Findings, Conclusions and Decision Public Works Variance EN-23-0010

Site: The Reserve Vault Location Variance
Parcel No. 0222323134

Re: **(EN-23-0010)** The Reserve Vault Location Variance - Public Works Variance Request

**RE: The Reserve — City file no. PL-PPLAT-22-0001, CPH Project No. 0228-21-001
Request for Public Works Standards Variance for Vault Location**

VAULT VARIANCE SETBACK

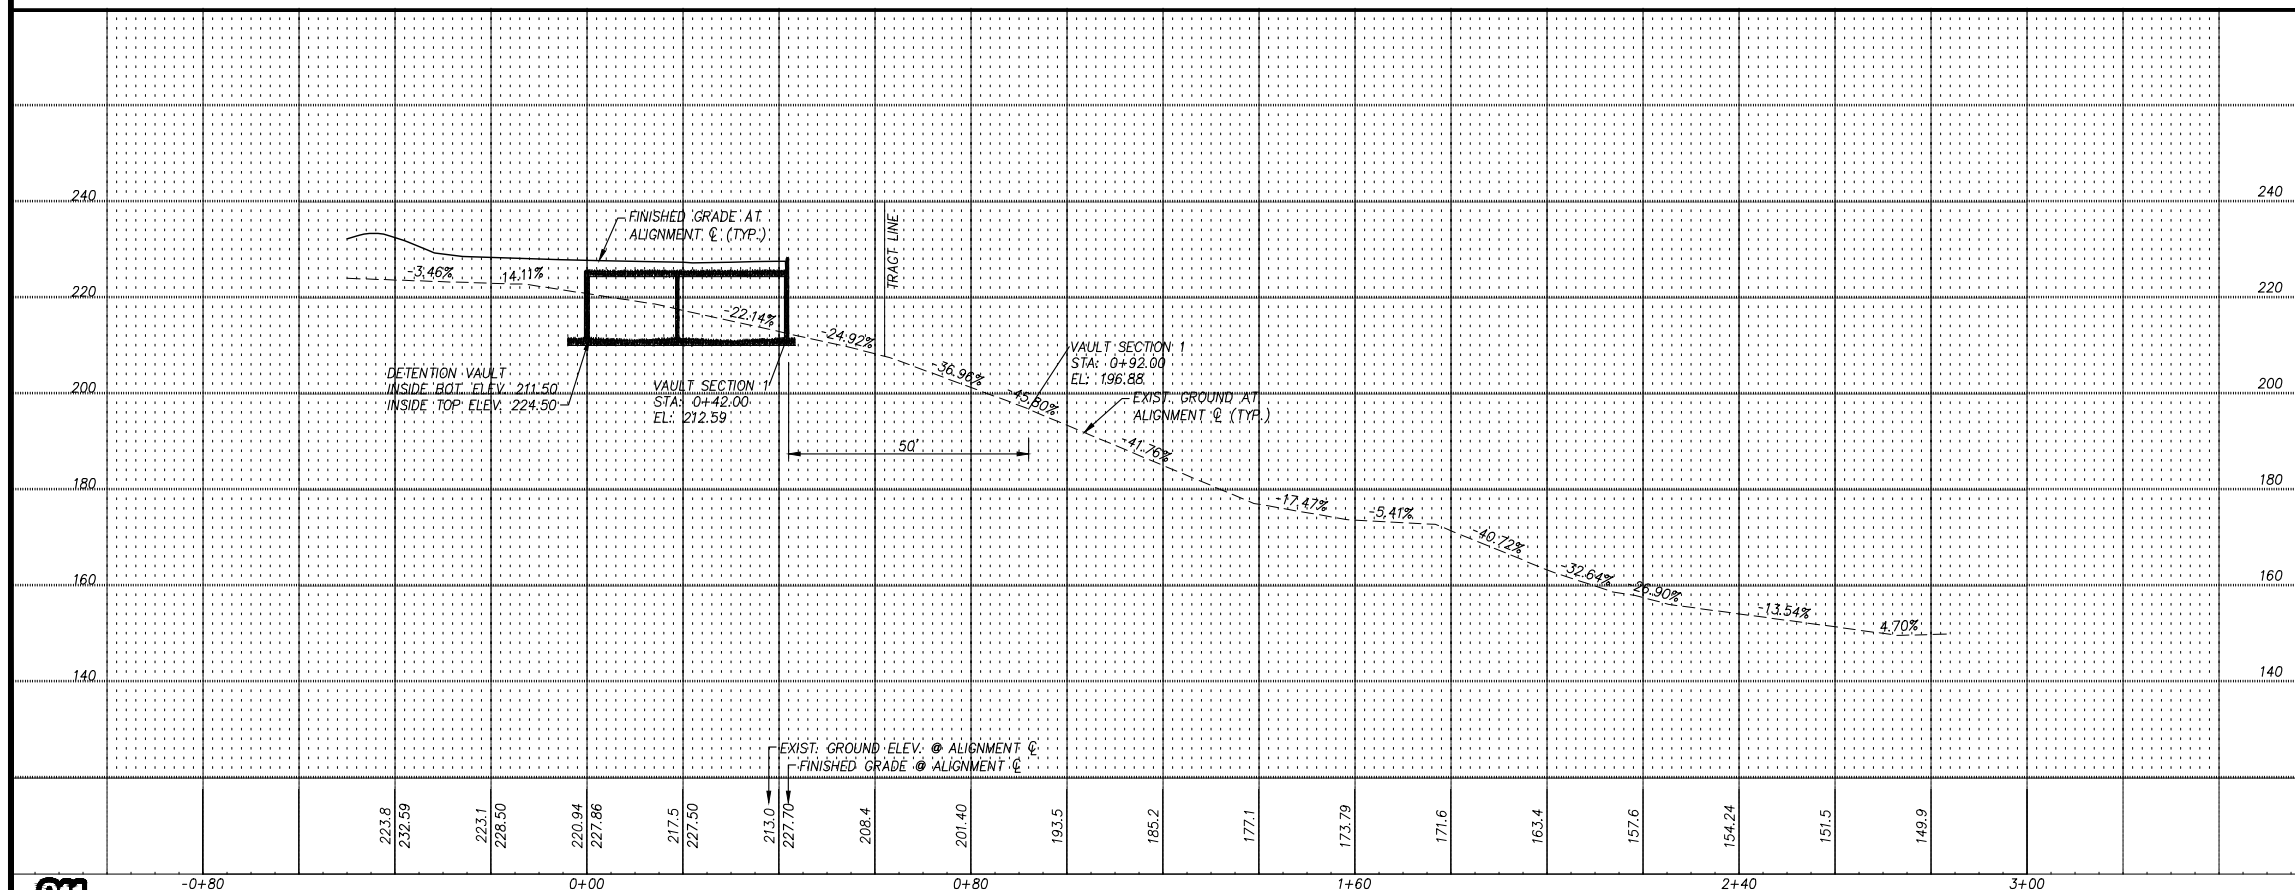
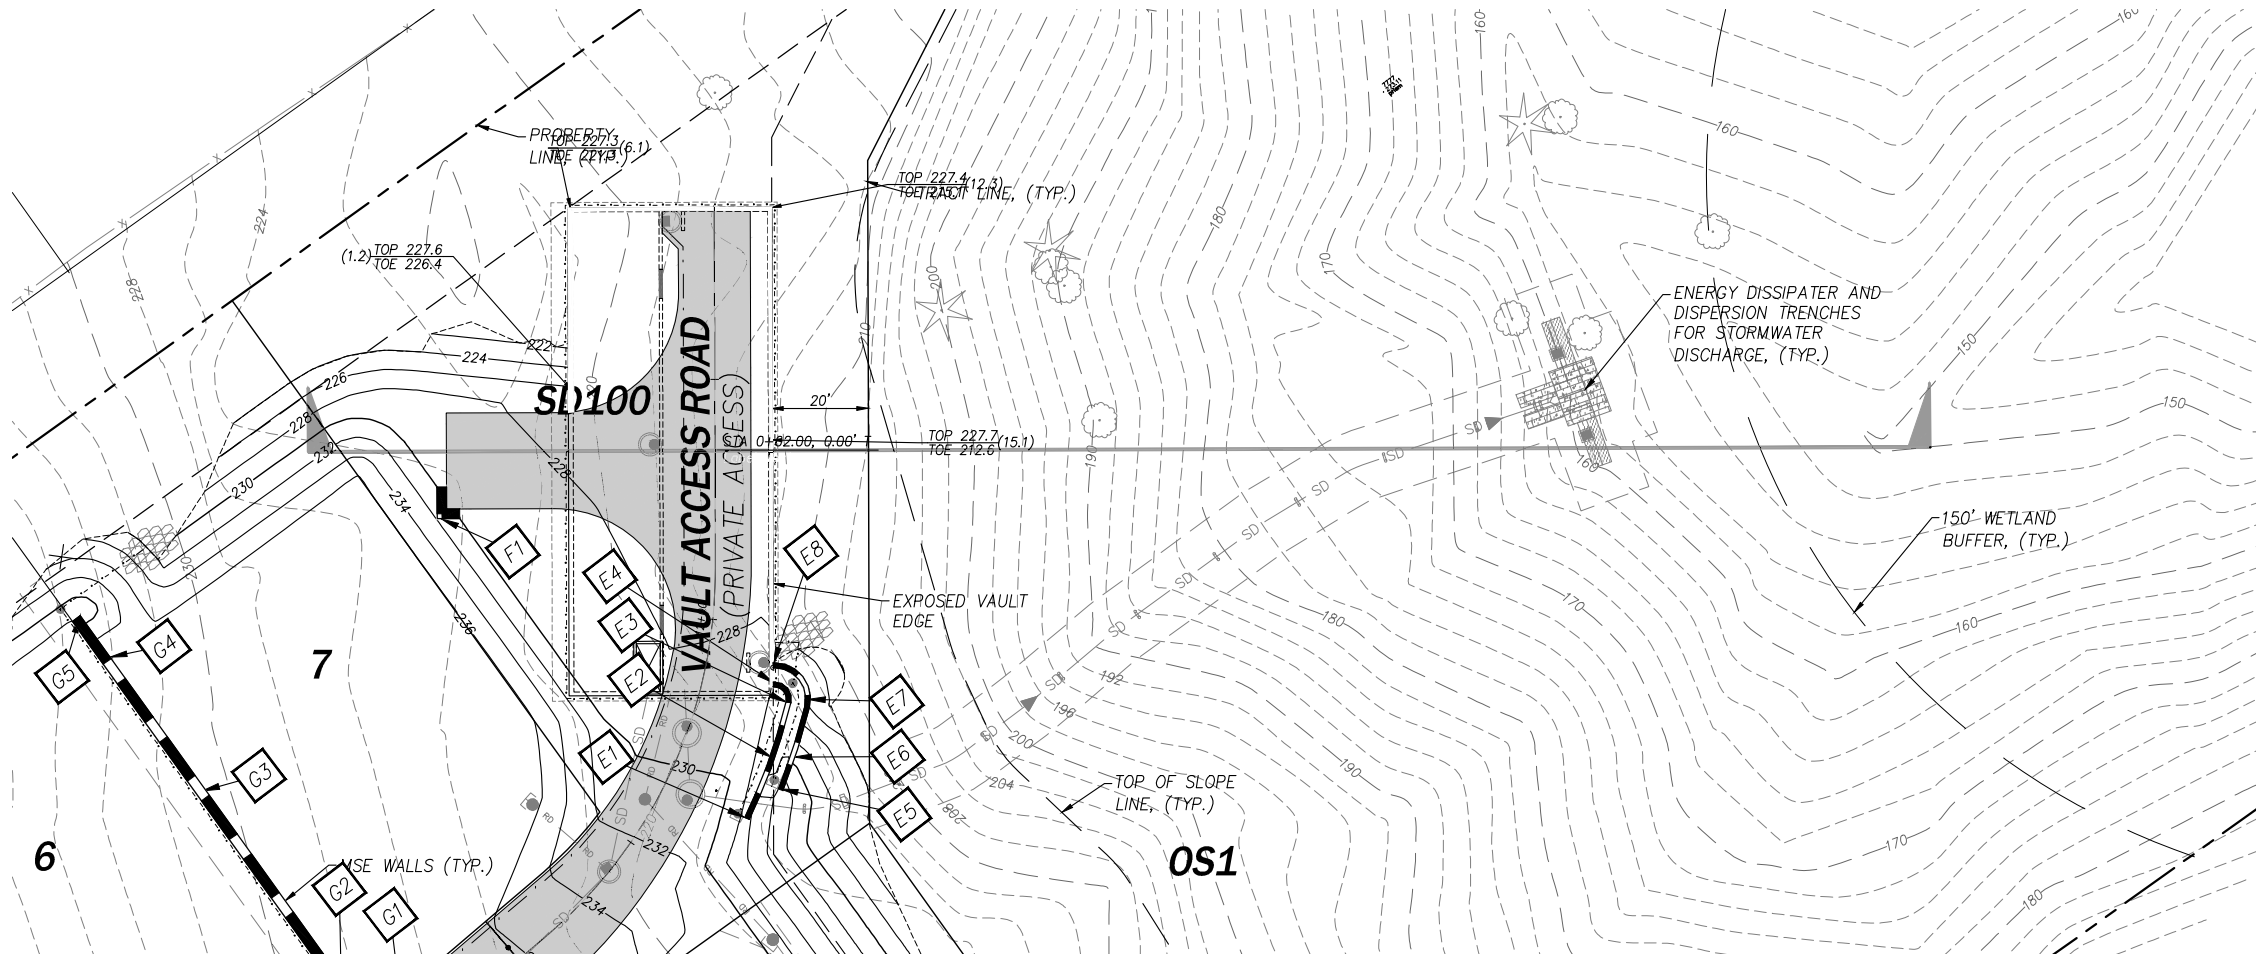
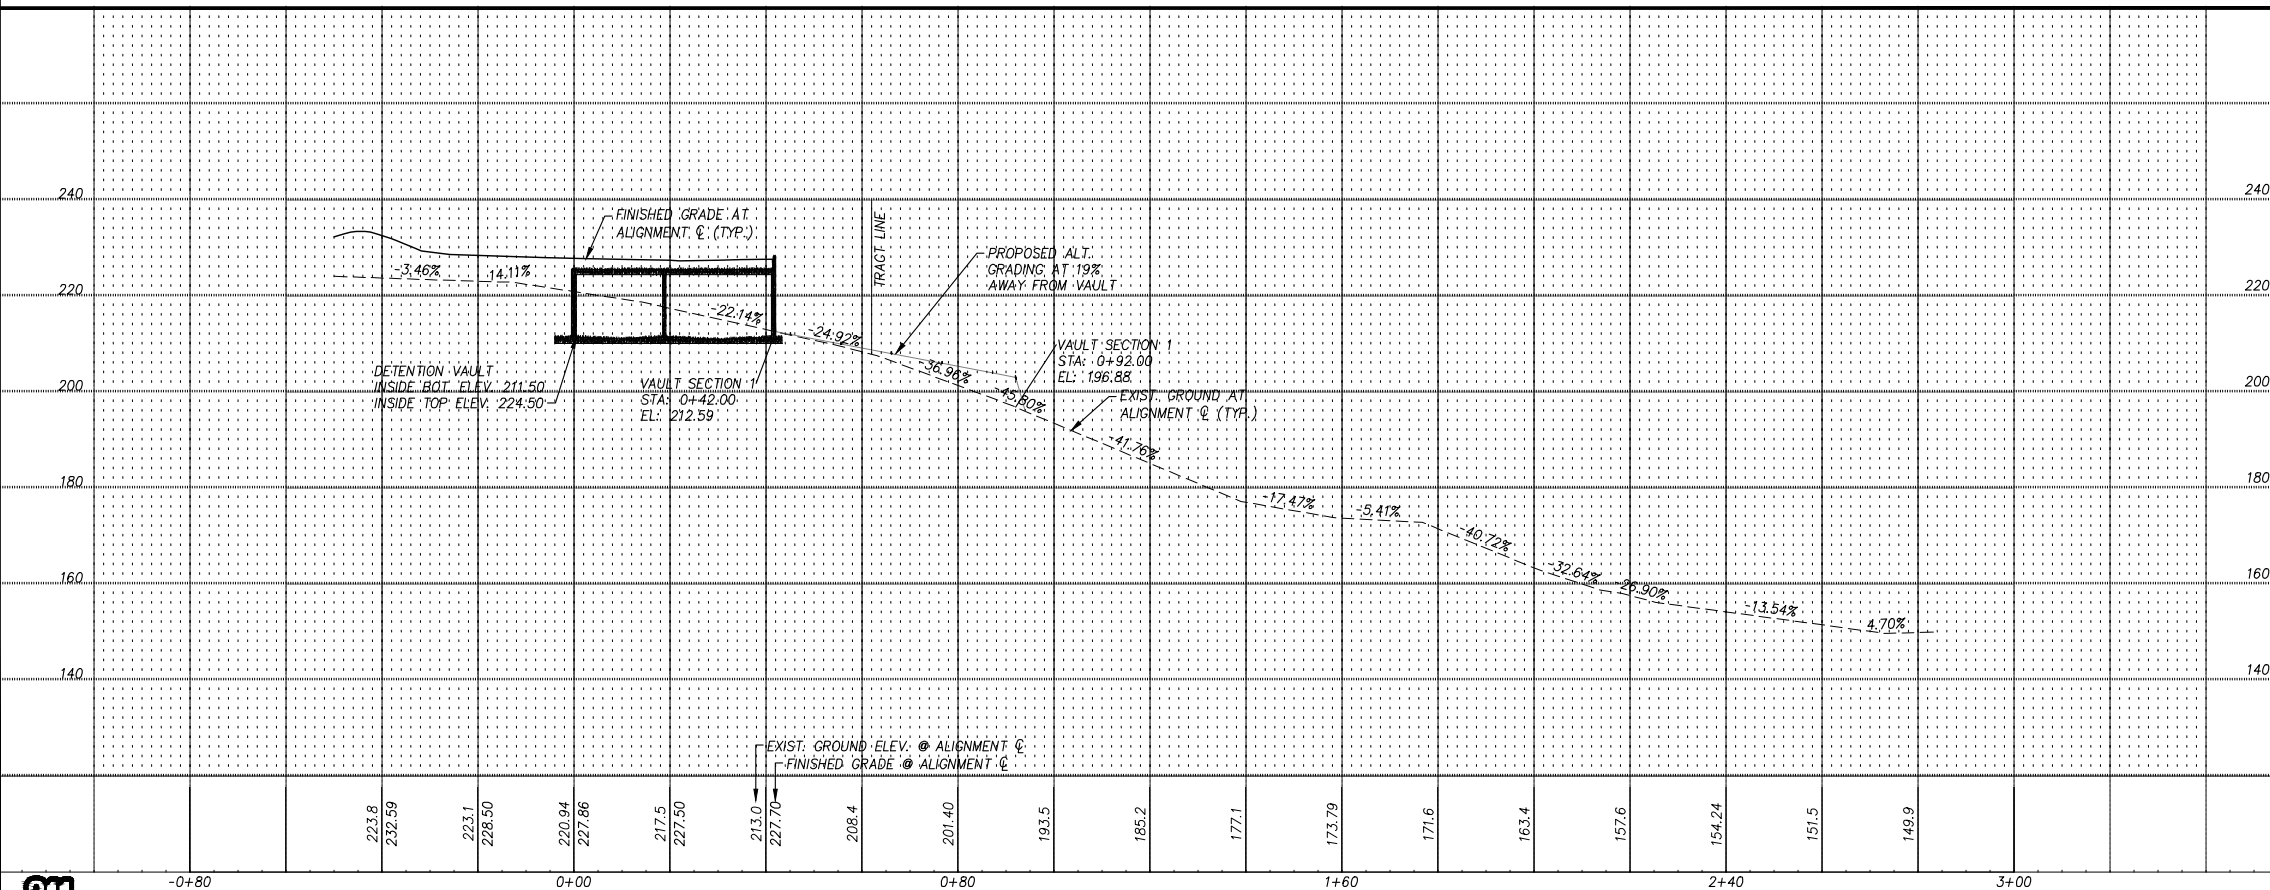
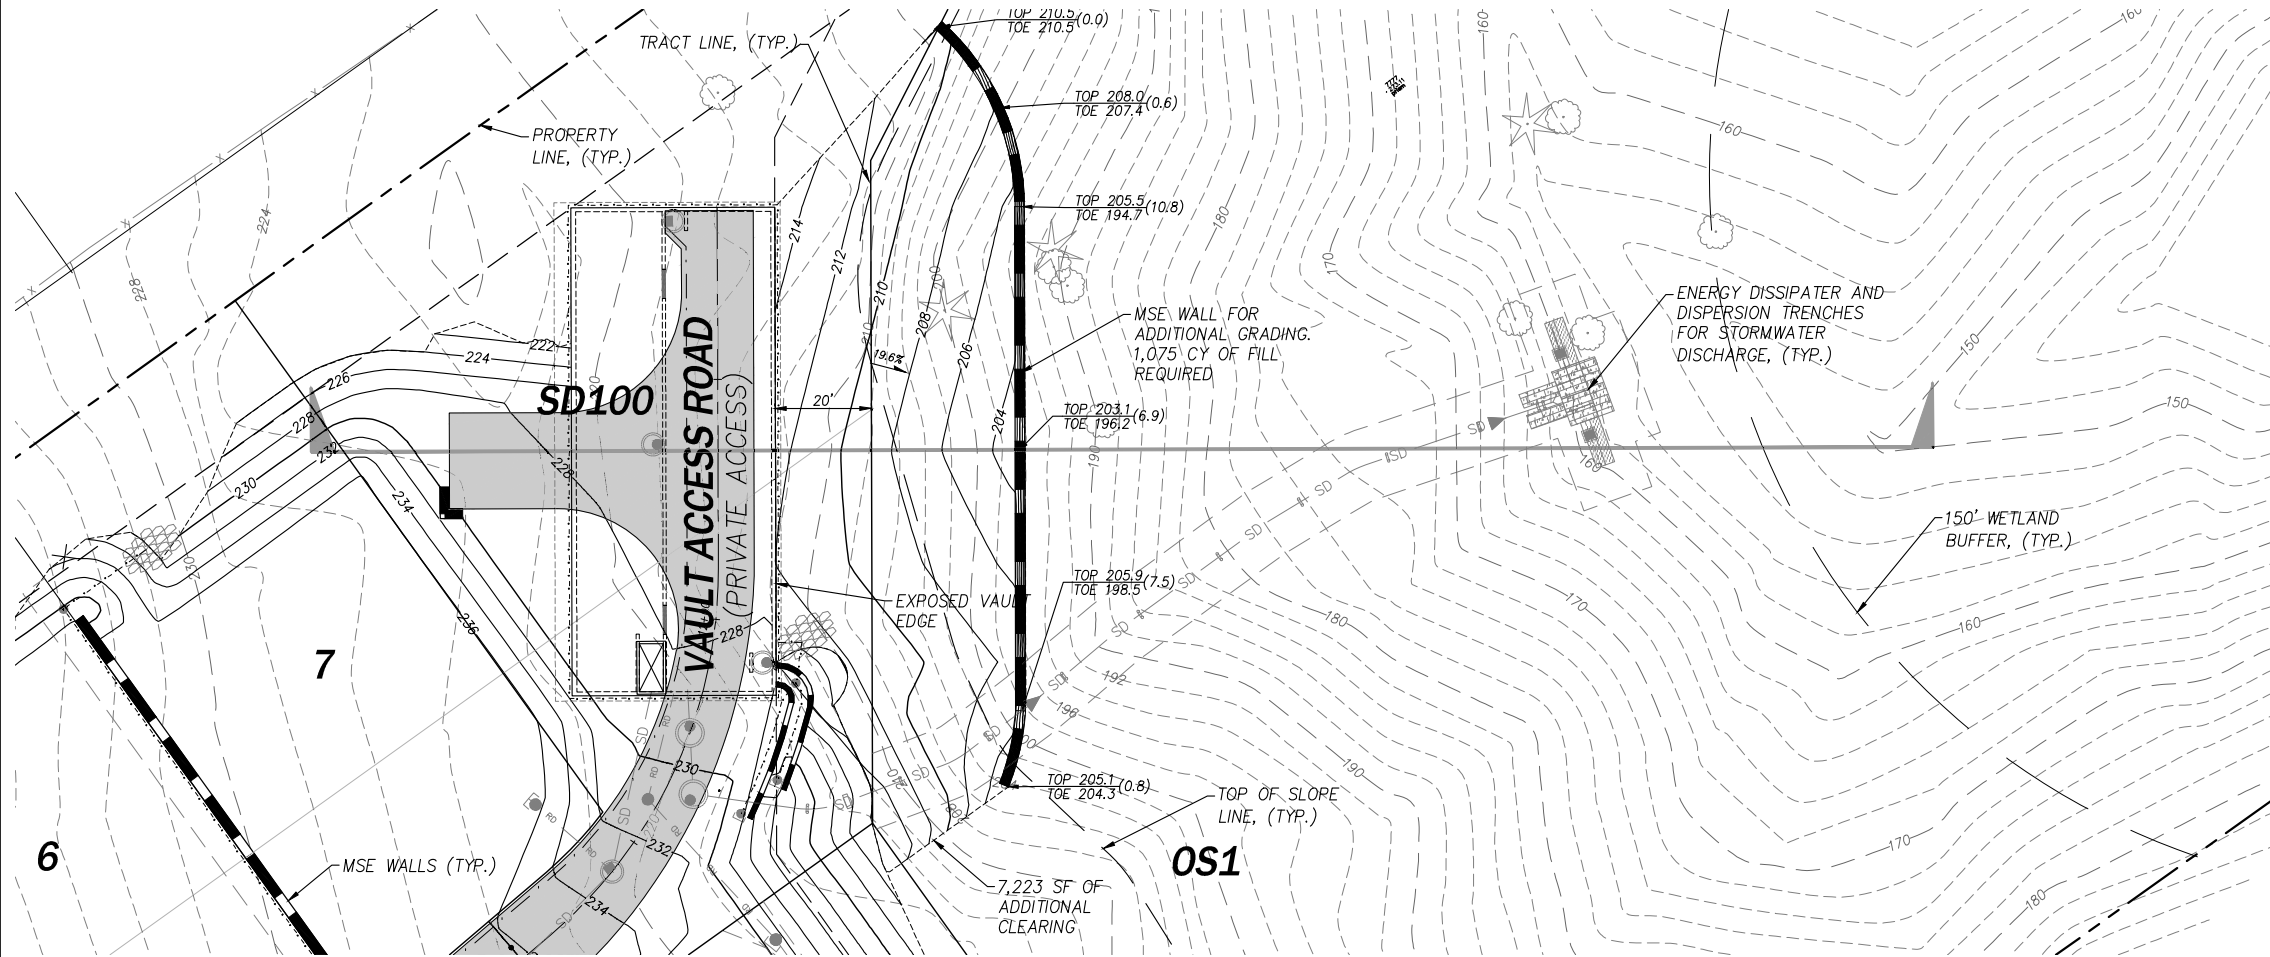
The topography of the property generally slopes west to east from higher elevations that average approximately 290 feet at the west boundary along Peacock Hill Ave to a low elevation on the order 152 feet in the vicinity of the nearest western limit of the on-site wetland buffer (see Exhibit 1, *Existing Conditions*). These elevation ranges result in an average maximum grade of just over 19 percent over the improved areas of the site. The project has been designed with the maximum allowable road grade of 15 percent, the use of daylight and tuck under style homes, and terraced retaining walls to minimize earthwork efforts and to maximize tree retention for the proposed new 14-lot residential community. The proposed vault location is an important part of the grading design and native tree retention. The grading of the site is shown in the enclosed Exhibit 4, *Overall Grading Plan*. A plan and profile of the vault and the existing slope is shown in the enclosed Exhibit 6, *Vault Variance Setback*.

VAULT VARIANCE SETBACK ALTERNATE

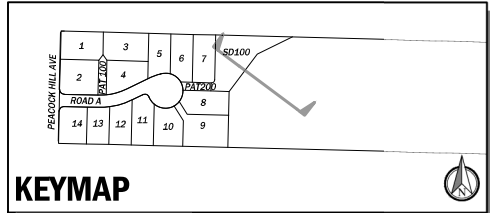
square feet that extends into the Critical Area Tract OS1. This would result in a reduction in OS1 area, removal of additional trees, increasing the earthwork imbalance by approximately 1,000 cubic yards and require an additional 160 feet of approximately 11' tall MSE retaining wall. This alteration would be undesirable or impractical as it would reduce the area set aside to protect the wetland, steep slopes, and existing vegetation on the east side of the project, increase fill required and the imbalance in earthwork, require additional retaining walls. Although this alternative would be supported by the PWS, it would result in an undesirable and impractical design given the existing topography of the site. This second alternative is shown on the enclosed Exhibit 7, Vault Variance Setback Alternative.

The second alternative that was determined to be feasible and provide strict compliance with PWS, would be to grade out the area east of the detention vault into the critical area tract. This alternative looks at keeping the vault and residential lots in their current location but fills the 50 feet east of the detention vault exposed wall to provide a slope of less than 20 percent. This alternative would provide strict compliance to PWS by filling an approximate 7,200 additional square feet that extends into the Critical Area Tract OS1. This would result in a reduction in OS1 area, removal of additional trees, increasing the earthwork imbalance by approximately 1,000 cubic yards and require an additional 160 feet of approximately 11' tall MSE retaining wall. This alteration would be undesirable or impractical as it would reduce the area set aside to protect the wetland, steep slopes, and existing vegetation on the east side of the project, increase fill required and the imbalance in earthwork, require additional retaining walls. Although this alternative would be supported by the PWS, it would result in an undesirable and impractical design given the existing topography of the site. This second alternative is shown on the enclosed Exhibit 7, Vault Variance Setback Alternative.

The City Engineer's analysis concurs with the Applicant's claim that strict compliance is impractical due to the reasons stated by the applicant.
